Work Order ID 69303 -

Item Name: Crosstube Turning Detail

DRAWING NO. D412-664-243	TITLE CROSSTUBE ASSEMBLY (412 HI AFT)	REV. E	DART AEROSPACE LTD ENGINEERING ORDER		D.E.O. NO. D412-664-243-E-1	SHEET NO. SHEET 1 OF 2	SCALE NTS
DRAWN	CHECKED <i>MP</i>	MFG. APPR. <i>E</i>	APPROVED <i>MP</i>	DE APPR. <i>#</i>			
DATE 11.03.31	DATE 11/03.31	DATE 11.03.31	DATE 11/03.31	DATE 11.03.31

PURPOSE:

**D412-664-243
ASSEMBLY DETAIL**

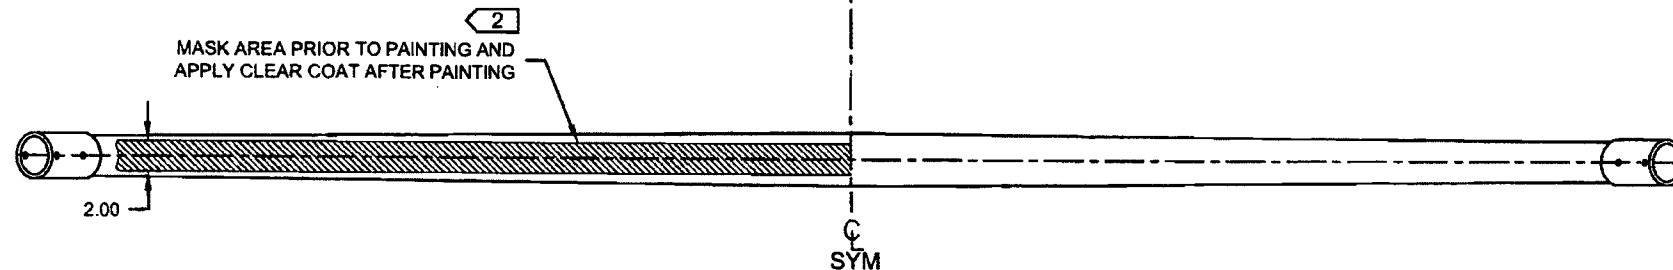
REMOVED ABRASION STRIP IN FAVOR OF A THIN LAYER OF PROSEAL 890.

WAS:

D2856-600-1009 ABRASION STRIP
D3189-1 CHAFING SHIELD (1, INSTALLED OVER ABRASION STRIP)
MS21920-28 CLAMP, 2X
2 PL

IS:

D3189-1 CHAFING SHIELD (1, INSTALLED OVER PROSEAL 890)
MS21920-28 CLAMP, 2X
2 PL
